TECHNICAL MEMORANDUM

Re: The Reserve Development Project – Third Party Review

The City of Gig Harbor (City) has contracted with Grette Associates to assist in the review of the Wetland and Fish and Wildlife Habitat Assessment Technical Memorandum (the “Memo”; dated November 7, 2022) that was prepared by Soundview Consultants, LLC (SVC).

Figure 1. Observed wetland snags

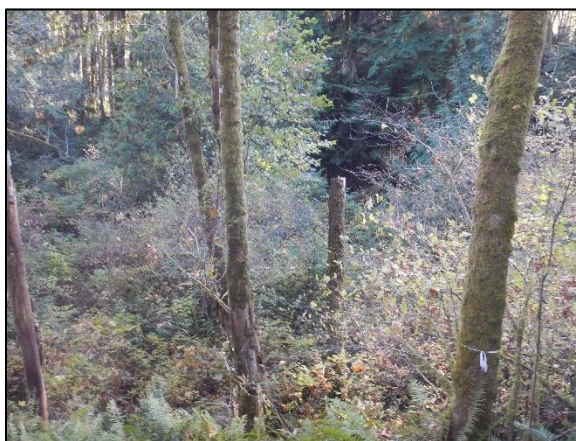
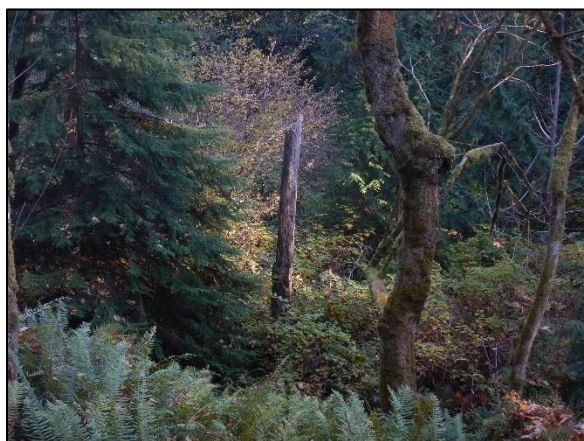
Grette Associates identified several snags within Wetland A (Figure 1). In addition, the 2016 wetland evaluation (Russell and Associates 2016) also noted large down woody debris and standing snags within Wetland A. No points were given for having standing snags within the wetland; therefore, an additional point should be given to Question H 1.5.
